State of Alaska
Department of Fish and Game
Nomination for Waters
Important to Anadromous Fish

Anadromous Water Catalog Volume R-1
USGS Quad KETCHIKAN B-5
Name of Waterway _____
Anadromous Water Catalog Number of Waterway 101-45-10600

DATE: September 18, 1991
FILE NO: SE-92-002; SE-92-003
PHONE: 225-2027
SUBJECT: Forest Practices
Inspection -
Salmonberry II;
Coon Cove O.S.

KETCHIKAN B-5

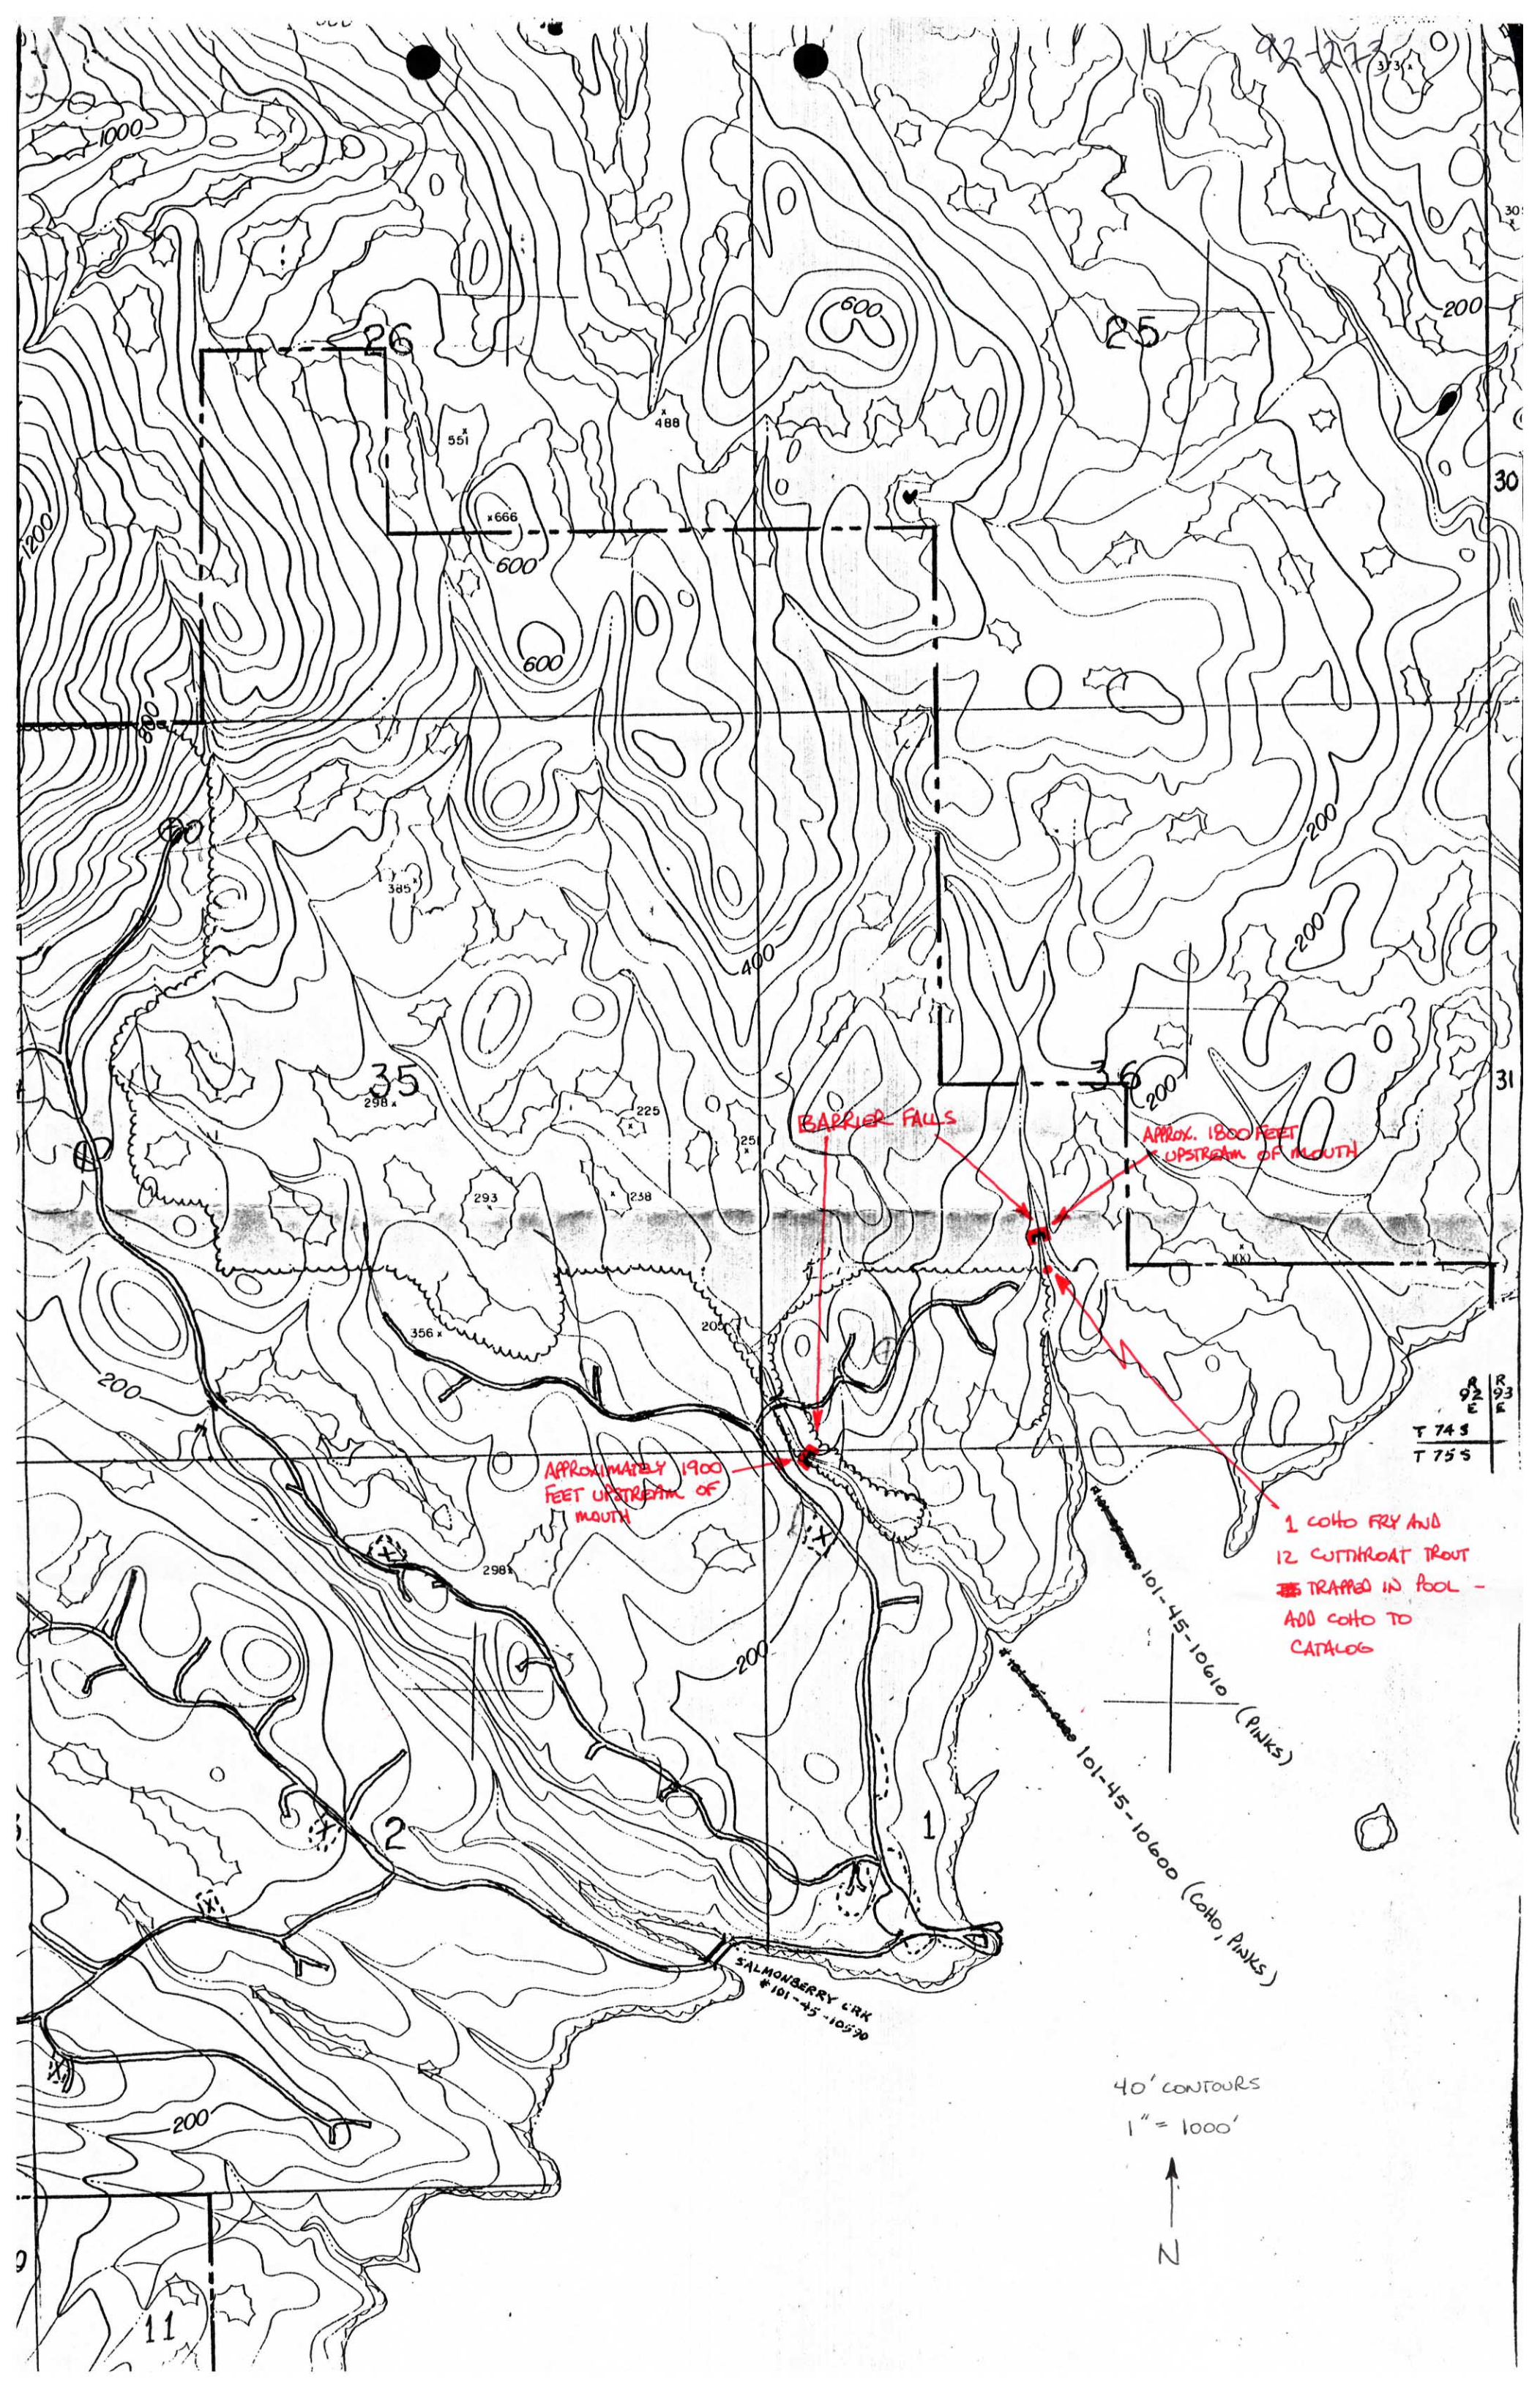
BARRIER FALLS

APPROXIMATELY 1900
FEET UPSTREAM OF
MOUTH

1 COHO FRY AND
12 CUTTHROAT TROUT
TRAPPED IN POOL -
ADD COHO TO
CATALOG

101-45-10610 (PINKS)

101-45-10600 (COHO, PINKS)

15 TO 20 FOOT HIGH, STEEP CASCADING BARRIER FALLS (LACKING A PLUNGE POOL BELOW)
EXISTS APPROXIMATELY 1900 FEET UPSTREAM OF ITS MOUTH. EXISTING CATALOG SHOWS
ANADROMOUS PORTION OF STREAM EXTENDING BEYOND THIS BARRIER APPROX. 1980' FURTHER.
REVISE CATALOG AS INDICATED ON ATTACHED COPY OF KETCHIKAN B-5 CATALOG SHEET.
